9 Twin Orchard Drive  
Oswego, NY 13126  
December 5, 2002

Mr. John A. Grobe, Director  
Division of Reactor Safety  
US Nuclear Regulatory Commission  
801 Warrenville Road  
Lisle, IL 60532-4351

Could I talk to you about the lower head deposits? Originally the Incore tubes had a problem. I am thinking that if the problem was vibration, perhaps they moved as I have shown in my Sketch 1. This would present a possible fatigue problem at (or near) the weld fastening them to the reactor vessel lower head.

Sketch 2

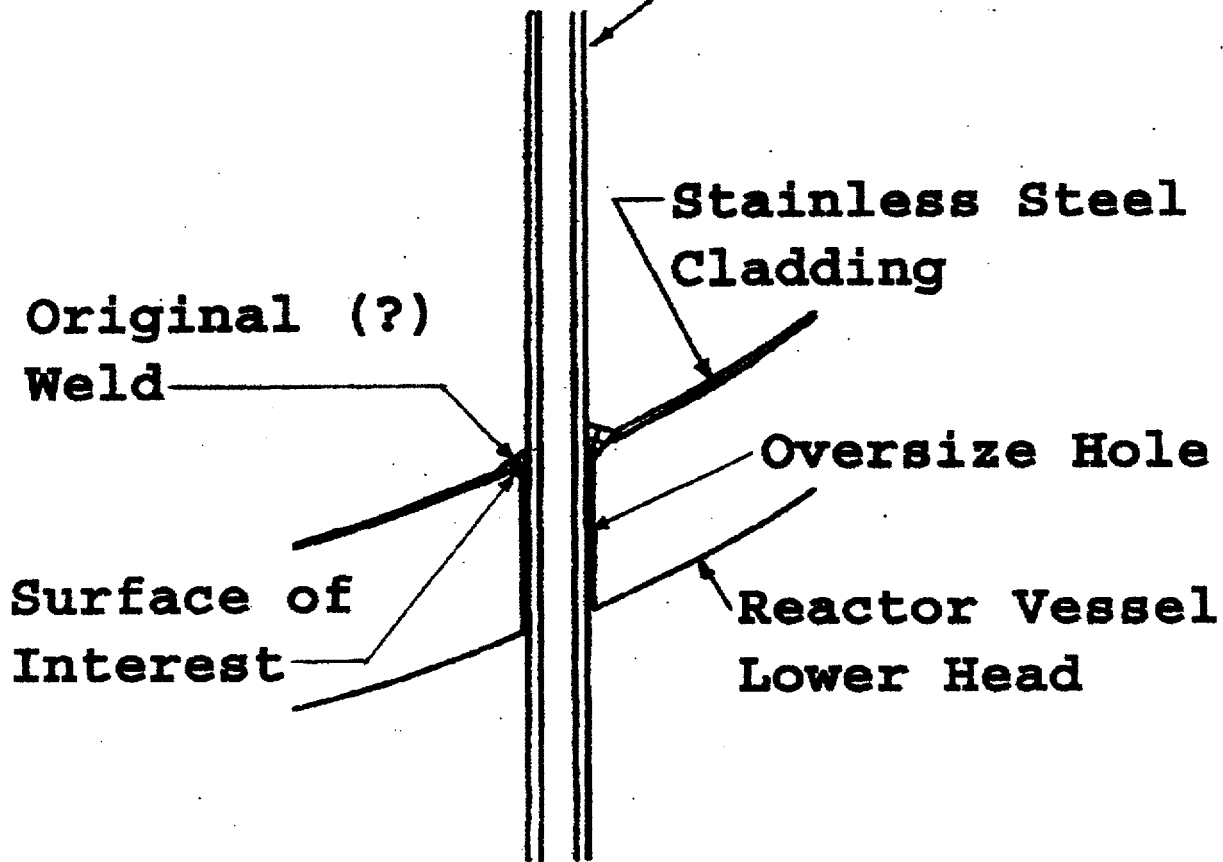
If the stainless steel cladding on the Davis-Besse reactor vessel lower head was put on a "battered" layer of another weld metal that was first welded to the carbon steel reactor vessel, there would be some challenging weld metal selection decisions needed for what I

have labeled the "Surface of Interest" on my Sketch 2. Note that it continues all around the Incore tube.

If there has been leakage of reactor coolant at my "Surface of Interest," it appears that it will drain away since there is no interference fit of the original Incore tube. However, if the Contingency Repair is made, this will no longer be the case. The weld(s) at the bottom of the head will pool any coolant just above them. Also, the severed tube will allow further leakage into the Incore tube, where, I guess, it would attack the Incore monitoring wires.

I don't like this repair method.
